CAUI-4 Ad hoc

Ryan Latchman, Mindspeed

20dB Informative channel update

Figure 83D-3 CAUI-4 chip-to-chip channel insertion loss

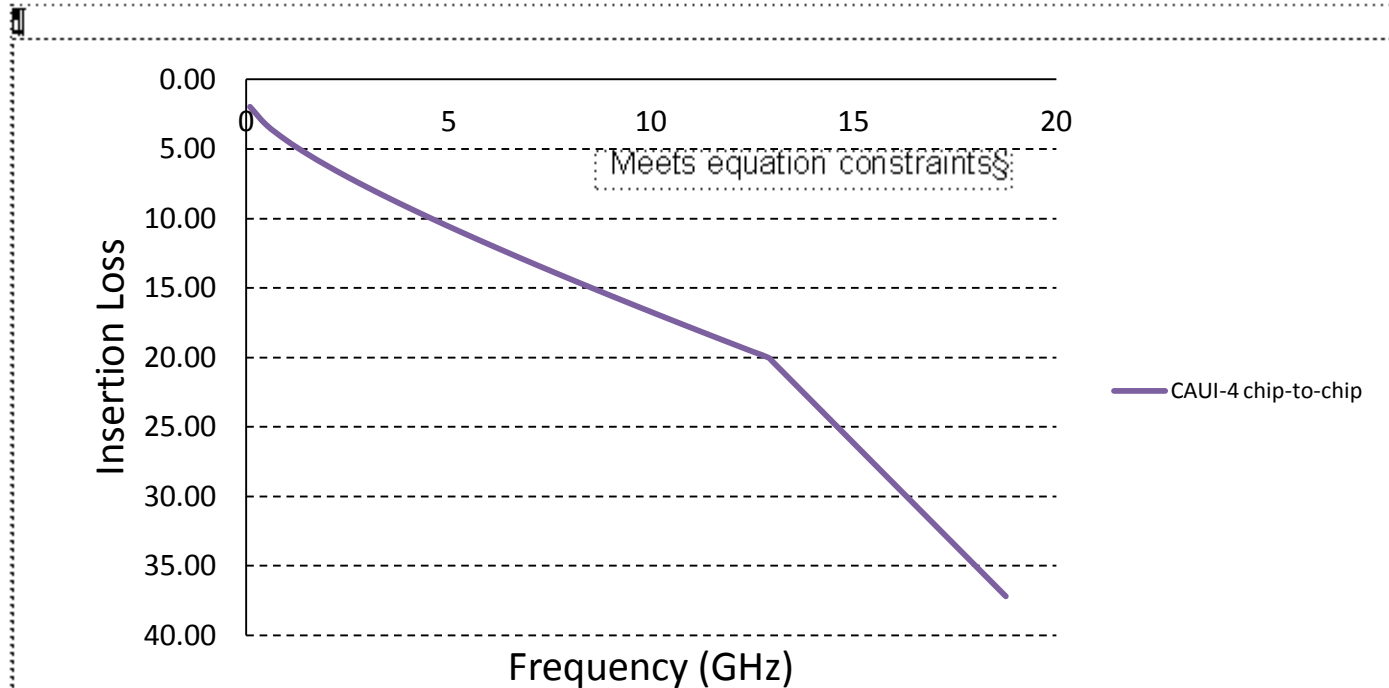
$$\text{Insertion_loss}(f) \leq \left\{ \begin{array}{ll} 1.083 + 2.543\sqrt{f} + 0.761f & 0.01 \leq f < 12.89 \\ -17.851 + 2.936f & 14 \leq f < 25.78 \end{array} \right\} \text{ (dB)} \quad (83D-1)$$

Updated Insertion Loss Figure
